Docket: 14313

Response to Office Action of March 13, 2003

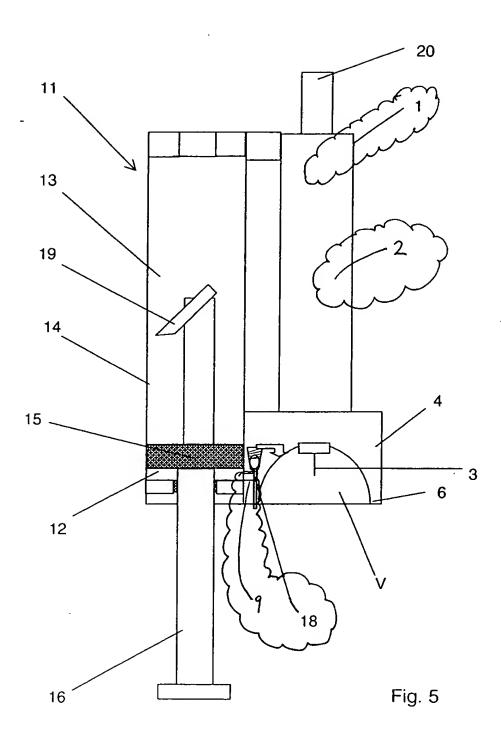
In the Office Action of March 13, 2003, the Examiner objected to the drawings for failing to show every feature of the invention specified in the claims, specifically the receptacle, rim and opening. The Examiner also objected to the drawings because reference characters "9" and "18" both point to the same structure in Figures 5 and 6. The three attached sheets of drawings: (1) include Figures 5, 6 and 7; (2) replace the original sheets containing Figures 5, 6 and 7; and (3) show the proposed changes, which are indicated by being enclosed within clouds.

Figures 5, 6 and 7 have been changed so reference characters "9" and "18" now have separate leaders that point to the passage and cut-off valve, respectively. Figures 5 and 6 have been changed to include reference character "2," which is recited in the specification as pertaining to the product reservoir and clearly indicated in Figures 1, 7 and 8 as filed. The words receptacle, rim and opening are no longer recited within the claims, though these features were clearly apparent in the figures as filed.
